Date Code Migration for Z8 Encore! XP[®] F0822 Series Flash MCUs

AN028001-0608

Abstract

Figure 1. Z8 Encore! XP[®] F0822 Series Flash Microcontrollers Block Diagram

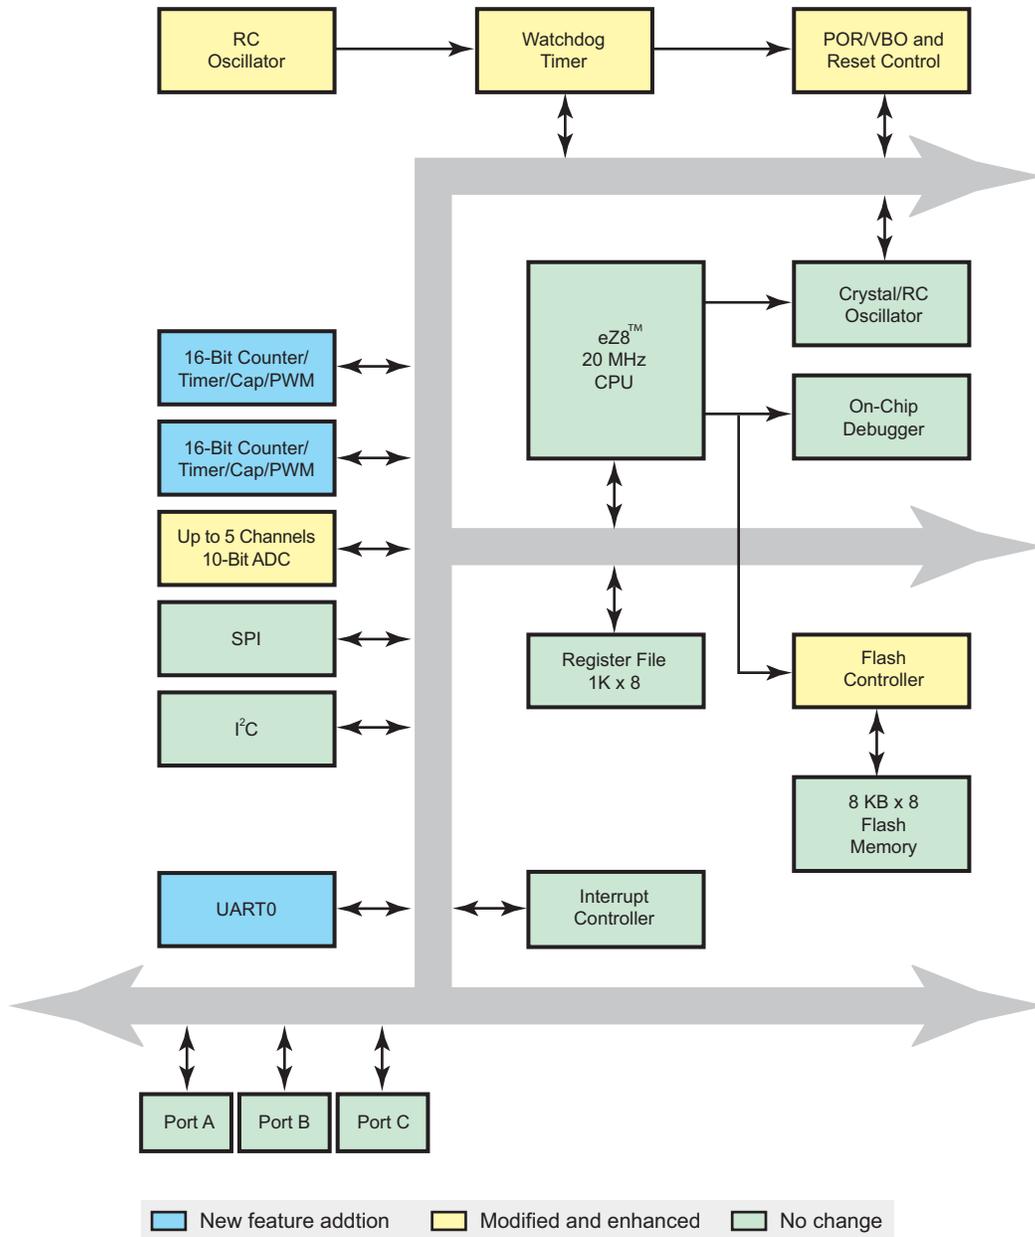
[Figure 1](#) displays an overview of the Z8 Encore! XP F0822 Series Flash Microcontrollers modules that are different between the two versions of the Z8 Encore! XP F0822 Series Flash Microcontrollers silicon. The differences are described under three categories:

1. **No Change**—Modules in this category have identical features and are functionally compatible. Application design is not impacted.
2. **Modified and Enhanced**—Modules in this category have some modified and enhanced features. Application design may be impacted regarding WDT RC oscillator, Reset pin, DBG pin, SMR pin, and Flash Protection features.
3. **New Upward-Compatible Feature Addition**—Modules in this category are upward-compatible and have some new features. Existing features are not affected. *Upward-compatible* means that new features are added using unimplemented register bits and modules operate in the same way as long as the bits are written as 0. Existing application designs are not impacted by this change.

Table 3 on page 3 lists the feature differences and impacts resulted due to migration from version AA to version BA of Z8 Encore! XP F0822 Series Flash Microcontrollers silicon. For convenience, it is color-coded to correspond to Figure 1.
